802.3dj D2.1

Comment Resolution

Electrical Track

Figure 176D–6—Reference insertion loss budget at 53.125 GHz

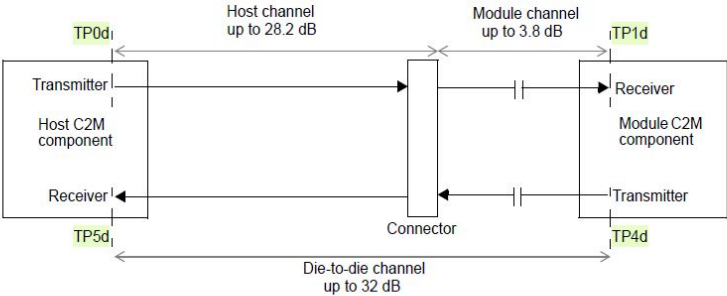
TP0d, TP1d, TP4d, TP5d are undefined in 176D. Also, the COM model includes assumptions above a device (die) and the related package, identifying different loss classes based on the package. Thus there is a conscious recognition of the device and device package in the specifications, though indirect.

Within this figure (or a new complementary figure) provide illustrations of the device, package, and the interfaces between the device and package, etc., as is done in Figure 178-2, Figure 178-3, and Figure 178-5. As a minimum define TPxd.

The highlighted pieces of text are the only occurrences of these test point names in Annex 176D.

PROPOSED ACCEPT IN PRINCIPLE.

The comment identifies a gap in the draft, lack of definition of test points in the figure (in the context of Annex 176D).

The device package is included in the reference model, but is not otherwise specified (e.g. there is no "package class" or "host class" that an implementation has to comply to). The suggested illustrations based on figures in Clause 178 are not suitable for this annex, since here the channel is not symmetric, and the test points TP0 and TP5 are not used. It is unclear what changes would satisfy this part of the comment. A detailed proposal is encouraged.

Definitions of TP0d, TP1d, TP4d, and TP5d are required. The editor will present suggested changes for CRG discussion.

Proposed change to the text of 176D.7:

This subclause describes the expected properties of the channels from TP0d to TP1d and from TP4d to TP5d, as depicted in Figure 176D–6. TP0d and TP5d represent the host C2M component output and input, respectively, at the die bumps, similar to the definitions of these test points in Table 179–6. TP1d and TP4d represent the module C2M component input and output, respectively, at the die bumps. These test points are typically not accessible in an implemented system.¶

Editors' recommendation: ACCEPT IN PRINCIPLE.
Change the text of 176D.7 as shown on this slide.

Figure 178-6

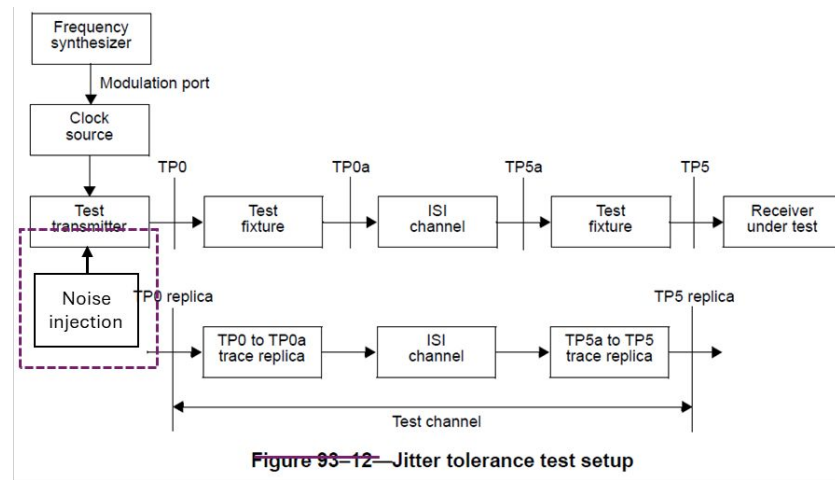
Figure 93-12 does not include broadband noise injection and therefore does not represent the specified jitter tolerance test setup. It is unclear why there are references to Annex 93A, 93C, and 120D.

Add a new figure to 178.9.3.5 that illustrates a test setup with both jitter and noise injection. Replace the second sentence of the first paragraph of 178.9.3.5 with a reference to this new figure.

C#304

C#304

C#302,303

C#305

Proposed text and new figure (178-6) →

Receiver jitter tolerance is verified for each pair of jitter frequency and peak-to-peak amplitude values listed in Table 179–13. The test setup shown in Figure 93–12, or its equivalent, is used. TP0v (TP5v) replaces TP0a (TP5a) in Figure 178-6 ~~Annex 93A, Annex 93C, and Annex 120D~~. The test channel meets the insertion loss requirement for Test 2 in Table 178–10. The synthesizer frequency is set to the specified jitter frequency and the synthesizer output amplitude is adjusted until the specified peak-to-peak jitter amplitude for that frequency is measured at TP0v. ~~The test procedure is the same as the one described in 178.9.3.4, with the following exceptions:~~ The test procedure is the same as the one described in 178.9.3.4 with the exception that transmitter output is measured with the jitter frequency and amplitude set according to Case G from Table 179–13. The transmitter meets the requirements in 178.9.3.4.1 with the added jitter from Table 179-13 included.

Editorial team recommendation: ACCEPT IN PRINCIPLE.
Implement the changes on this slide with editorial license..

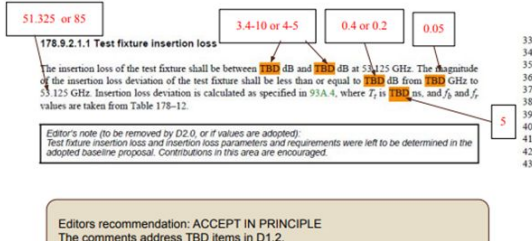
T70 to T90 test fixture specifications has multiple TBDs.

As initial values, we can use the values from clause 153 scaled by a factor of 2.

Use:
ILd between 3.4 dB and 10 dB at 53.125 GHz
ILd magnitude up to 0.4 dB from 0.05 GHz to 53.125 GHz
 T_i is 0.005 ns

PROPOSED ACCEPT IN PRINCIPLE.
The comment addresses an open TBD and the comment and the suggested remedy are reasonable, but consensus is not obvious.
Comments #189 and #190 suggest a different ILd range, different frequency range for ILd, and additional restrictions.
For CRG discussion.
